The following addendum supersedes information contained in the drawings and specifications issued of the project to the extent referenced. This Addendum forms part of the Tender Documents and is subject to all conditions set out in the contract documents

ELECTRICAL ADDENDUM E-02

Project title/Titre du projet
**ESQUIMALT GRAVING DOCK (EGD)
REPLACE MAIN DISTRIBUTION LINE (RMDL)**

**B.C. HYDRO (BCH)
POINT OF DELIVERY (POD)
SWITCHGEAR**

Drawing title/Titre du dessin
PROTECTION SINGLE LINE DIAGRAM

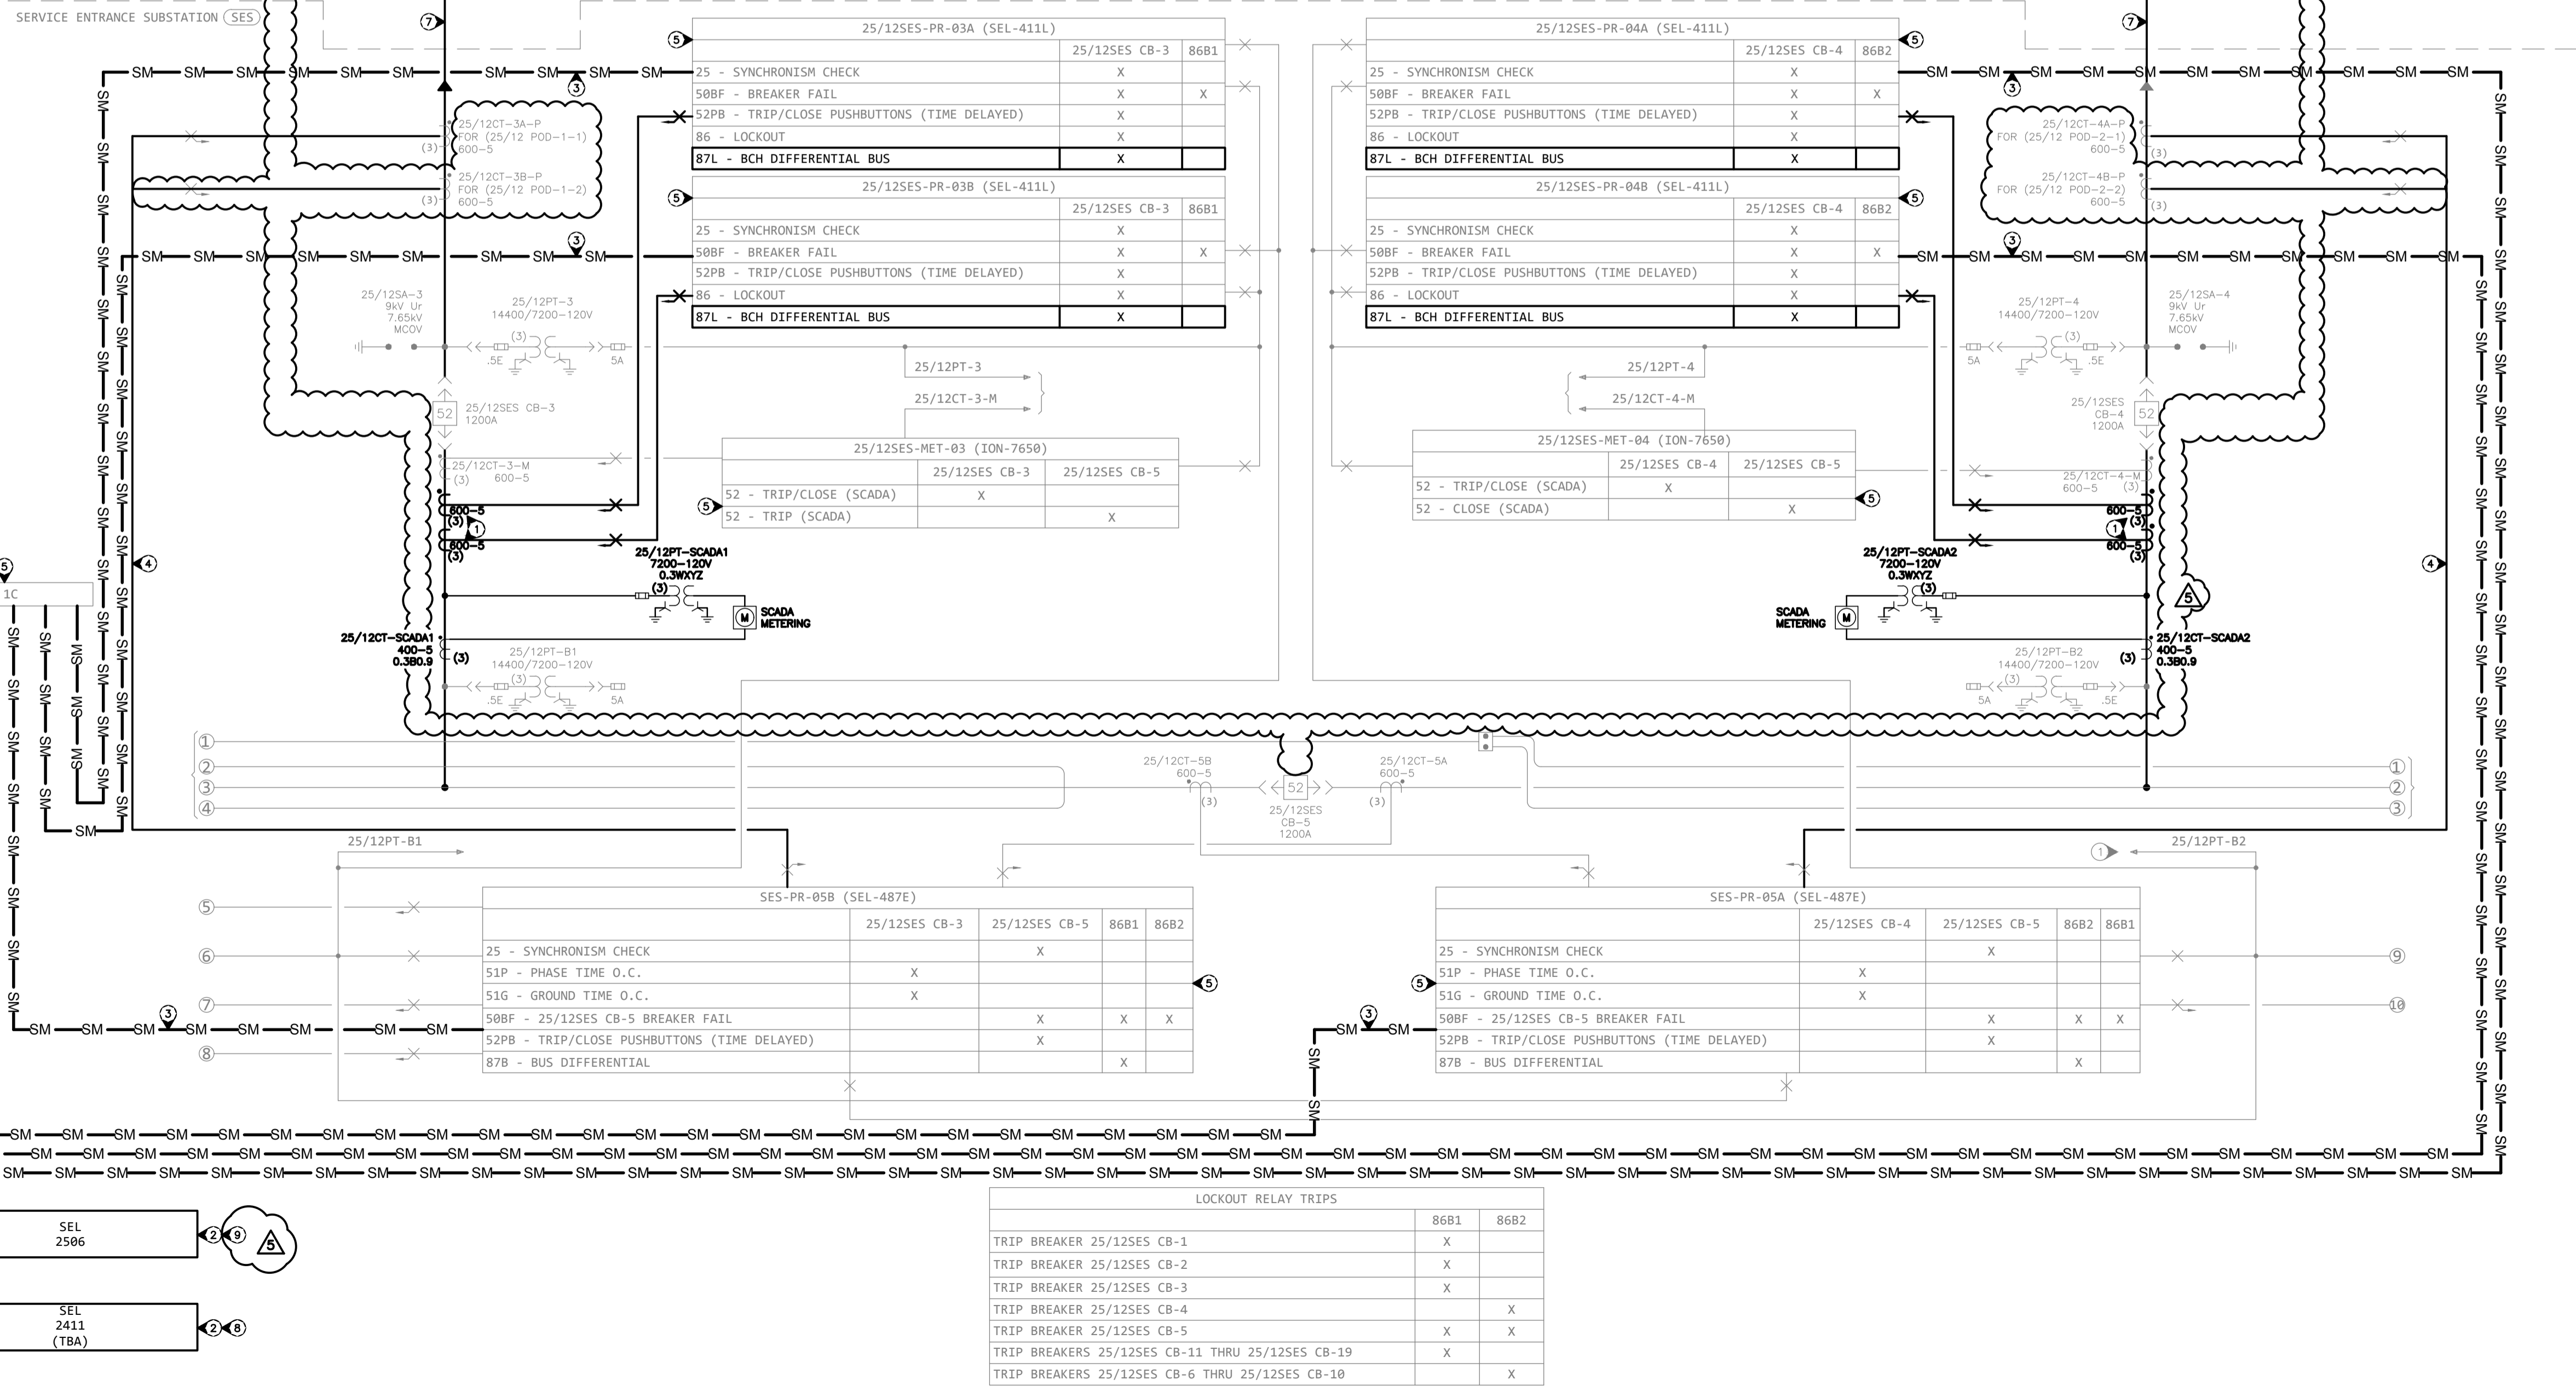
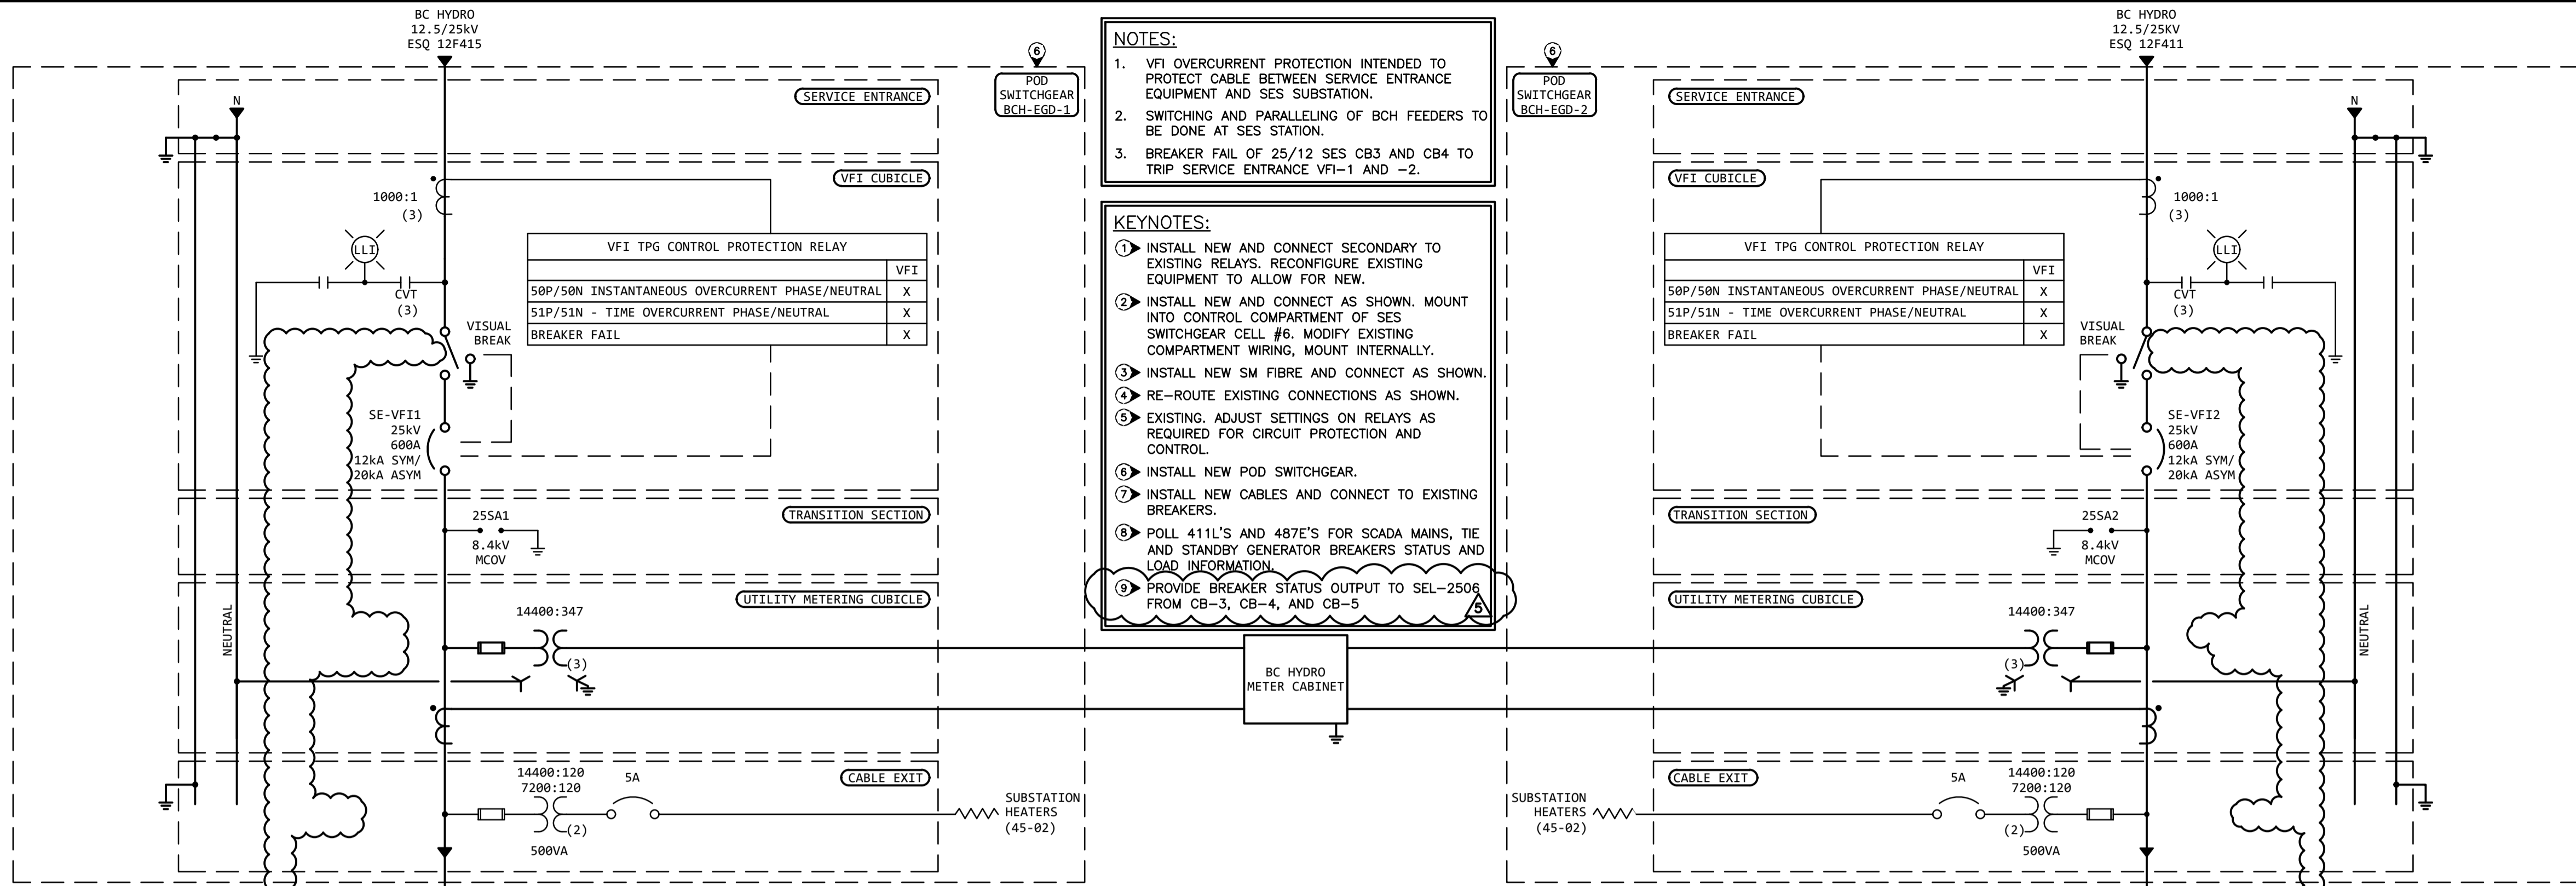
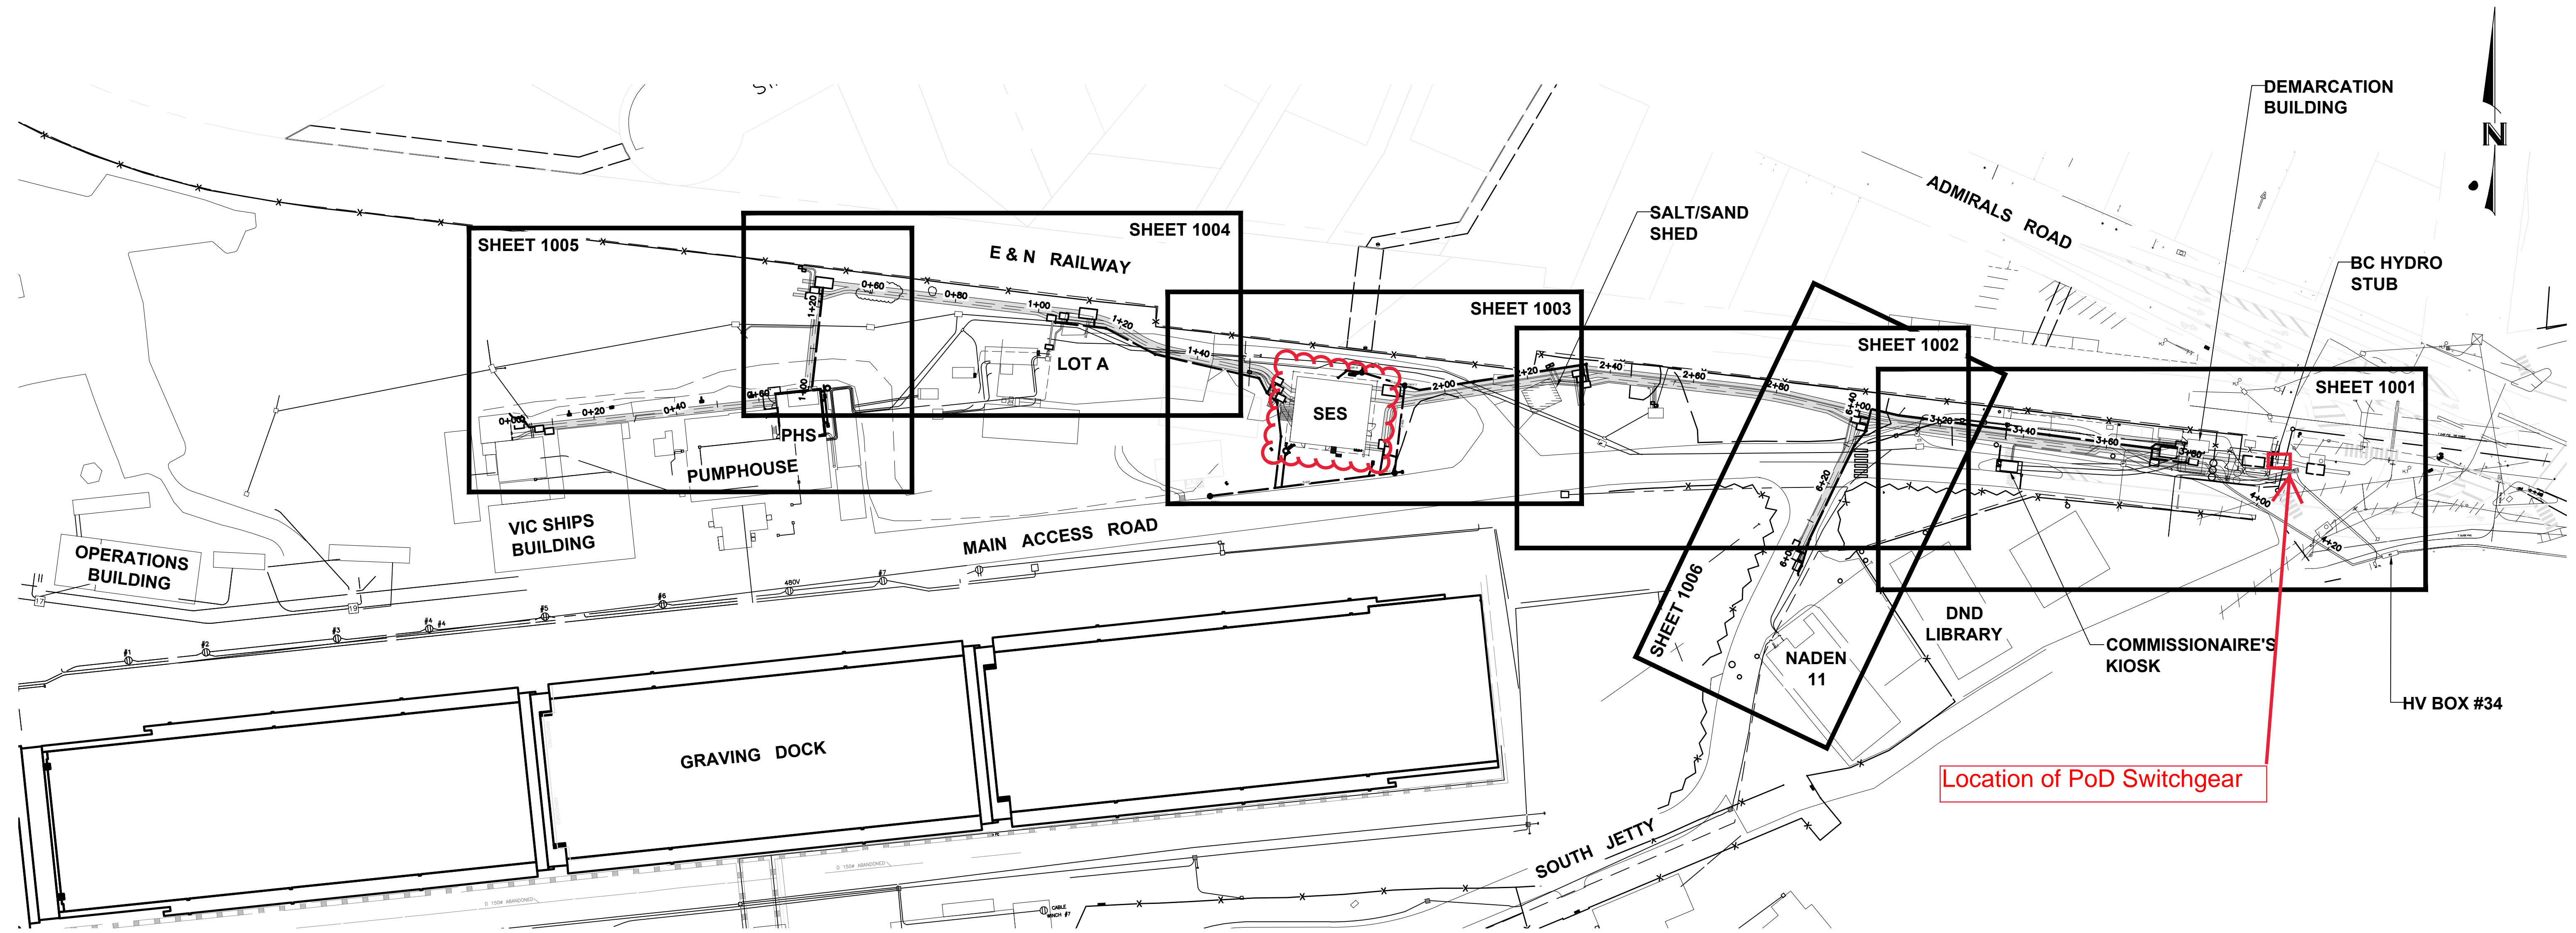
3 Drawing E06 - Kirk Key Interlock Detail Removed from Drawing E06

- a For clarity, the Kirk Key interlock system detail shown on drawing E06 is removed. The detail shown on drawing E05 shall remain, with the modification made as per Item 1 on this Addendum #2.

5 Drawing E06 – Power CT for Parallel Conductor

- a Existing power CTs 25/12CT-3B-P and 25/12CT-4B-P, which are on the second parallel conductor from BC Hydro, were not shown on drawing E06. These existing CTs were added into the drawing. Their revised connection to the protection relay shall be as shown.

- a Existing SEL411L protection relays shall be updated to match the firmware of the BCH 411L protection relays to match part number # 0411L0X6X5XXDDXH5E424XX. Existing SEL 411L part number in SES is 0411L0X6X5C8CCX35E424XX. Provide updated communications cards, firmware update and re-certification as required.
- b New SES SEL-2506 shall match new BCH 2506 at the Esquimalt substation and have the same part number: 250604414X.
- c Add keynote 9 on drawing E06.
- d Overall protection diagram shown below from BCH protection and Control:

13 CLARIFICATION: Fibre Panel on E06 Clarification

Q: Fiber panel shown E06 has an incorrect keynote. Please confirm a new rackmount panel is to be supplied and installed.

A: Fiber patch panel shown is existing and will be modified as per keynote as needed per project requirements.
